THE TRAILS FILING NO. 9

LOCATED IN THE SOUTH HALF OF SECTION 17, TOWNSHIP 12 SOUTH, RANGE 64 WEST OF THE 6TH PRINCIPAL MERIDIAN COUNTY OF EL PASO, STATE OF COLORADO

JOB NO. 25175.02
SEPTEMBER 21, 2022
SHEET 1 OF 5

PCD FILE NO. SF-21-036

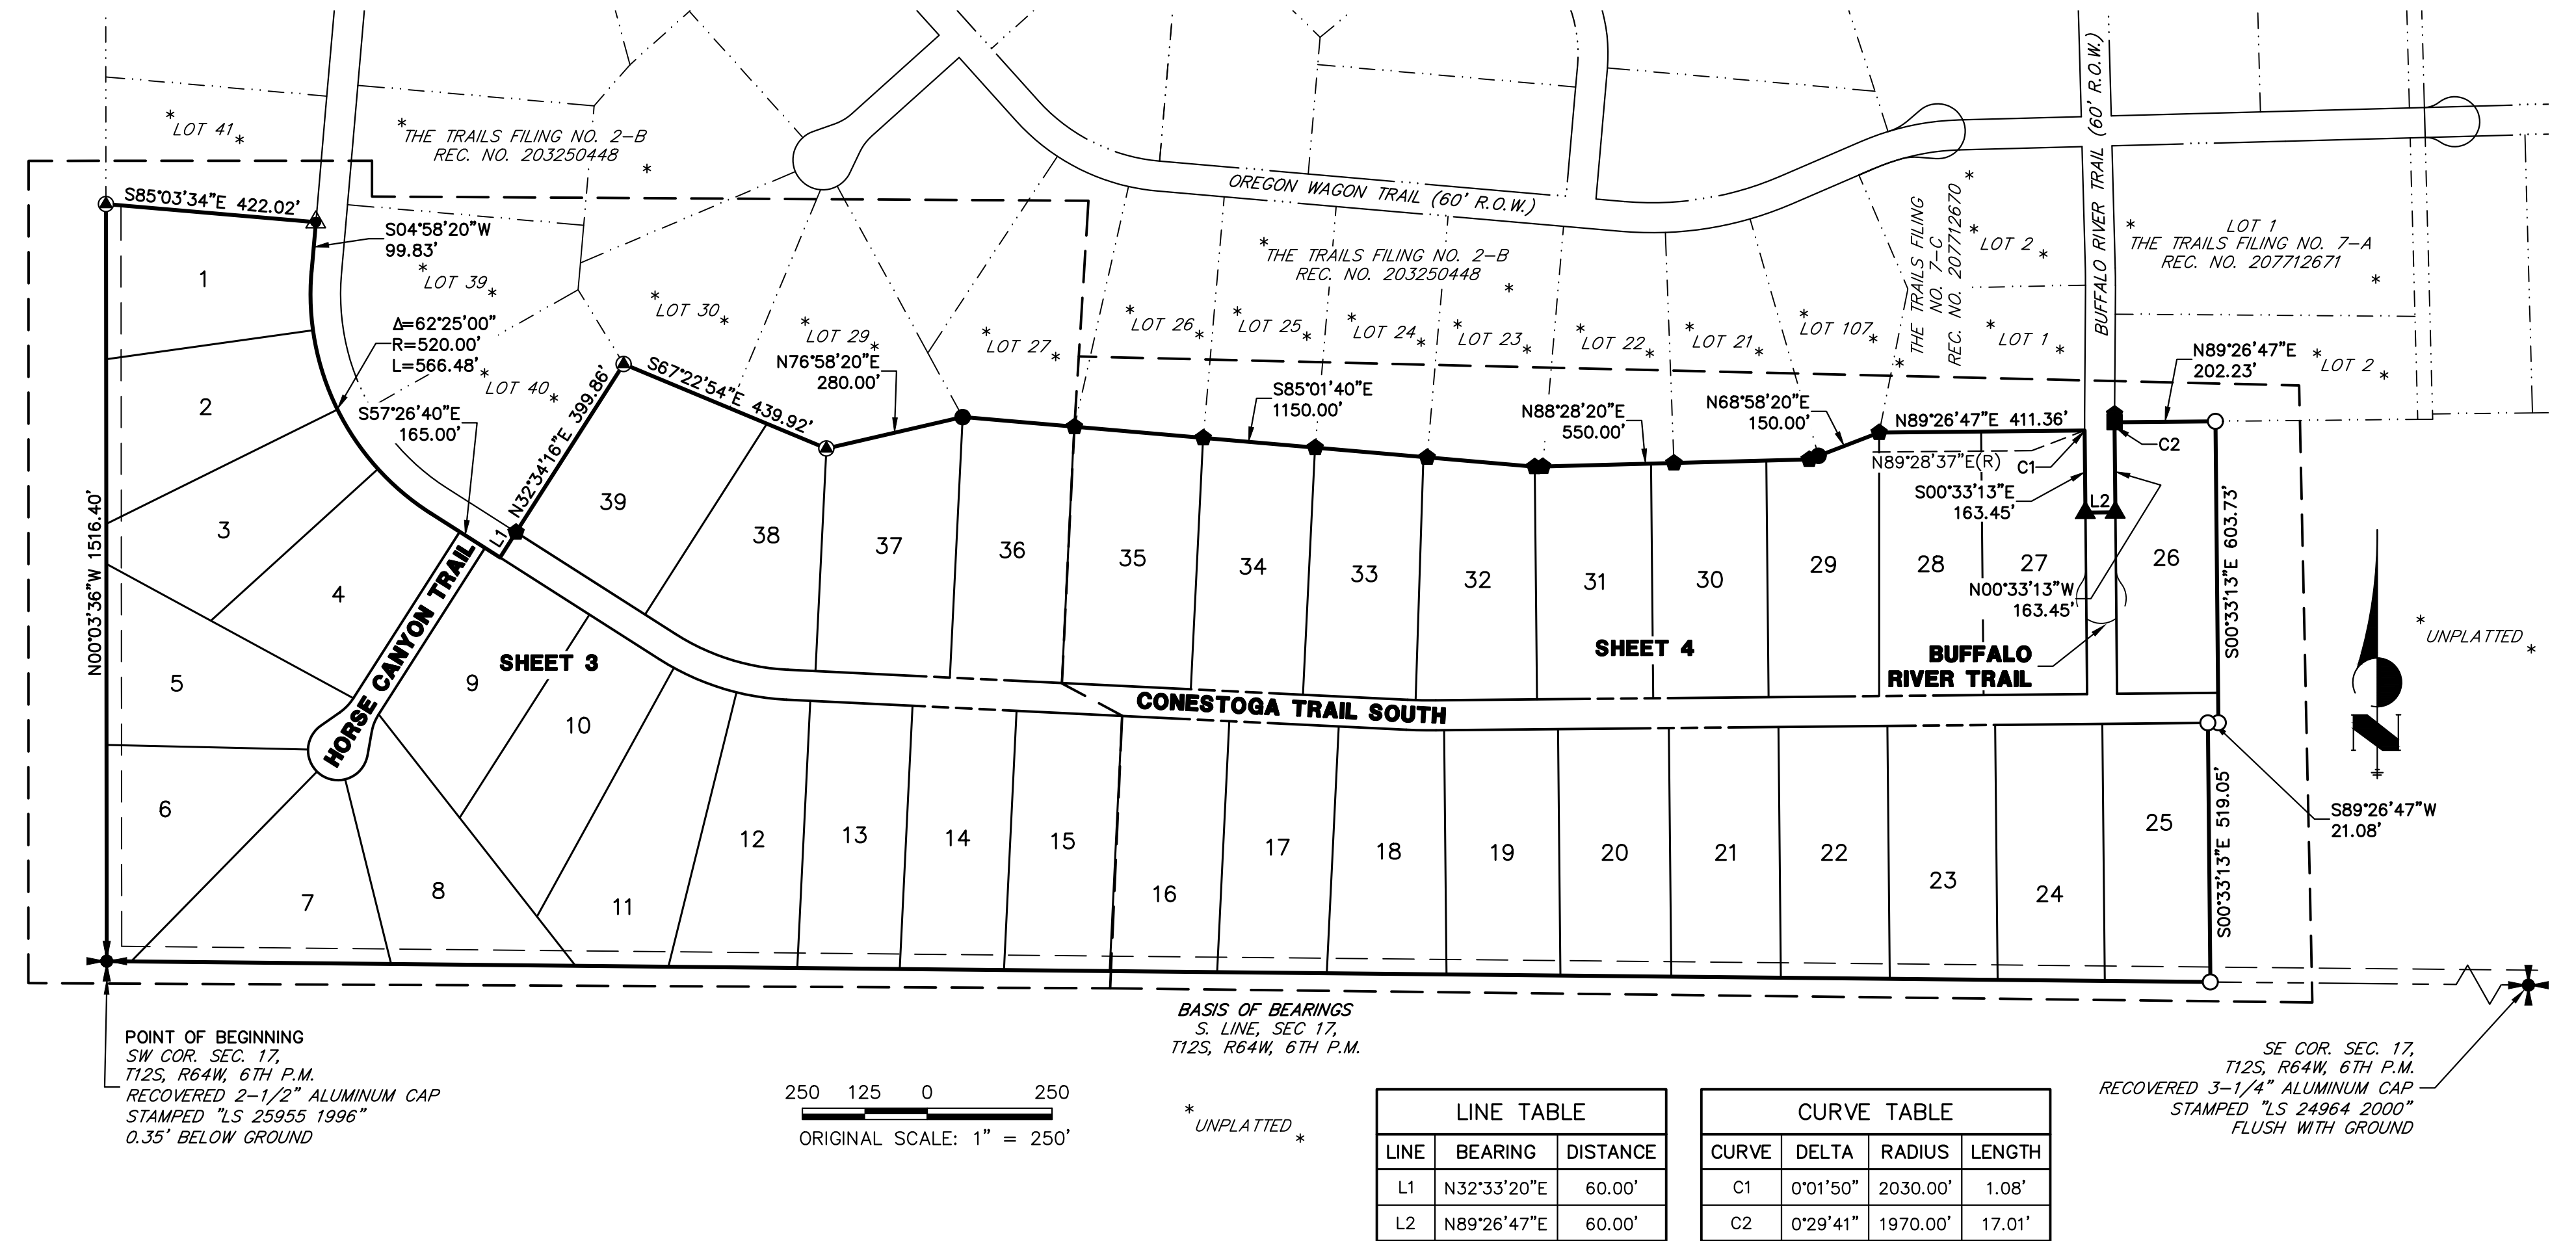
This should be discussed in the LOI also under the approval criteria... has the District provided and documentation that they are in agreement? WHO realistically maintaining the drainage ways on the properties, private property owners tend to NOT maintain the drainage ways causing up stream damages (flooding/erosion if drainage is blocked by homeowner). - Is the district to maintain these?

The Latigo Creek Metropolitan District is a new District and yes it will maintain this area as discussed in the Private Detention Pond Maintenance Agreement

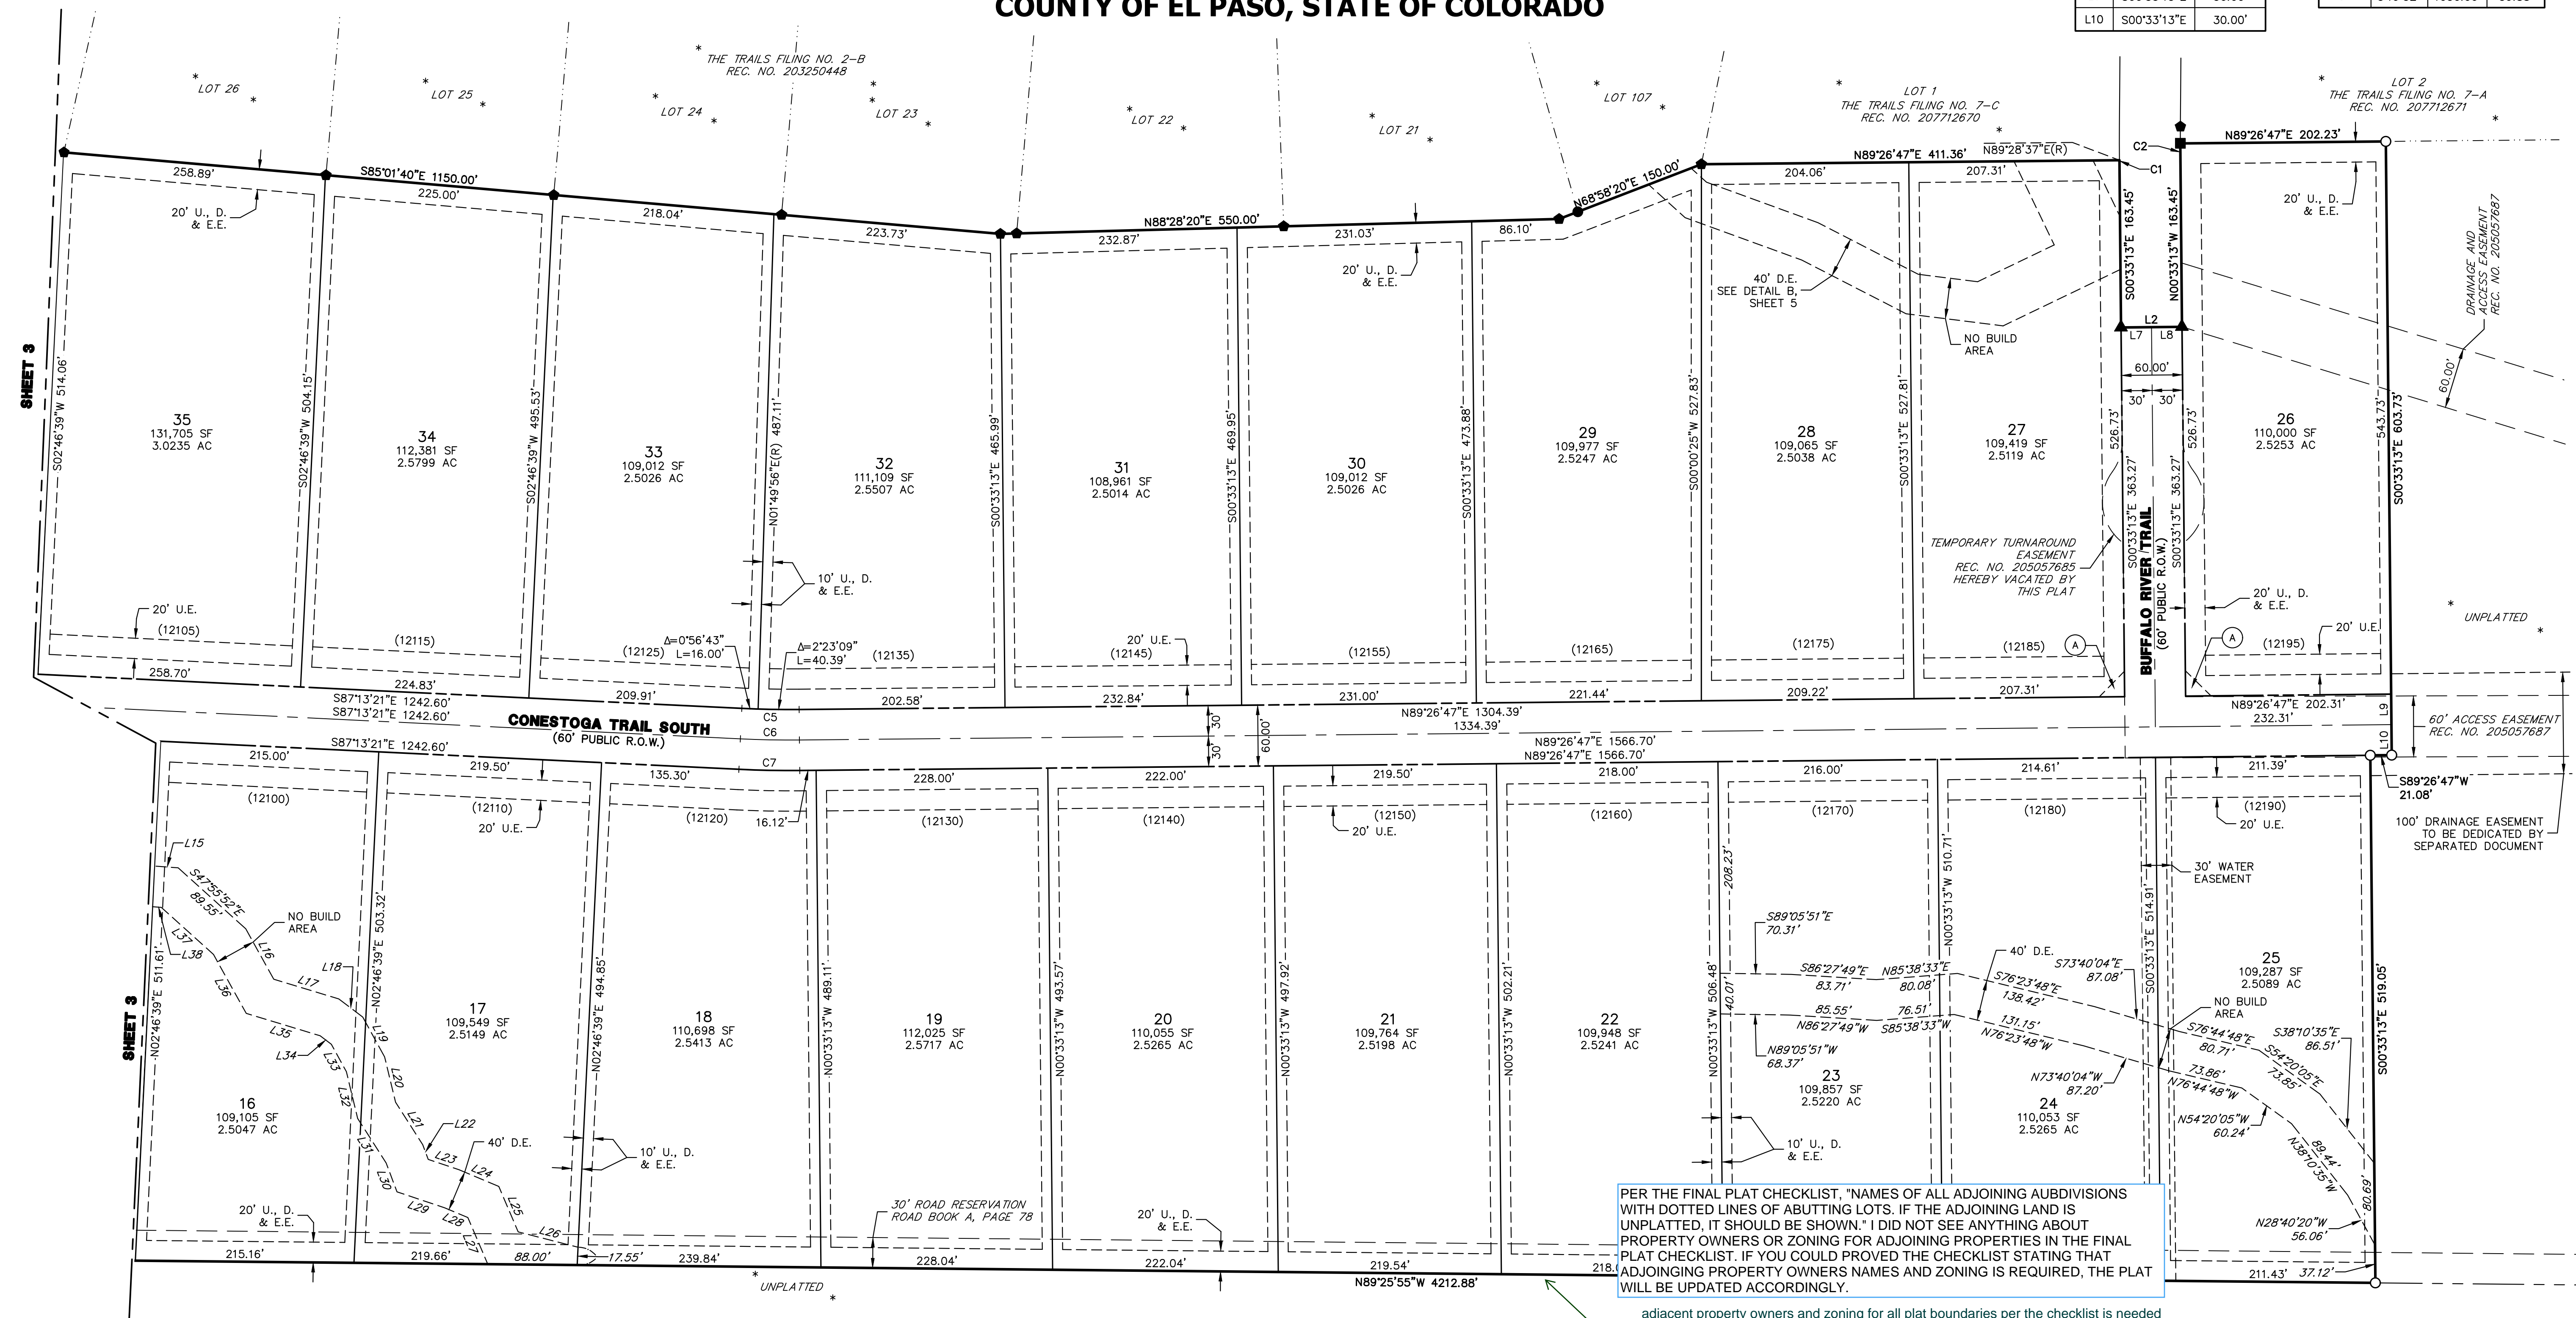
adjacent property owners and zoning for all plat boundaries per the checklist is needed

adjacent property owners and zoning for all plat boundaries per the checklist is needed

PER THE FINAL PLAT CHECKLIST, "NAMES OF ALL ADJOINING SUBDIVISIONS WITH DOTTED LINES OF ABUTTING LOTS. IF THE ADJOINING LAND IS UNPLATTED, IT SHOULD BE SHOWN." I DID NOT SEE ANYTHING ABOUT PROPERTY OWNERS OR ZONING FOR ADJOINING PROPERTIES IN THE FINAL PLAT CHECKLIST. IF YOU COULD PROVED THE CHECKLIST STATING THAT ADJOINING PROPERTY OWNERS NAMES AND ZONING IS REQUIRED, THE PLAT WILL BE UPDATED ACCORDINGLY.

PER THE FINAL PLAT CHECKLIST, "NAMES OF ALL ADJOINING SUBDIVISIONS WITH DOTTED LINES OF ABUTTING LOTS. IF THE ADJOINING LAND IS UNPLATTED, IT SHOULD BE SHOWN." I DID NOT SEE ANYTHING ABOUT PROPERTY OWNERS OR ZONING FOR ADJOINING PROPERTIES IN THE FINAL PLAT CHECKLIST. IF YOU COULD PROVIDE THE CHECKLIST STATING THAT ADJOINING PROPERTY OWNERS NAMES AND ZONING IS REQUIRED, THE PLAT WILL BE UPDATED ACCORDINGLY.
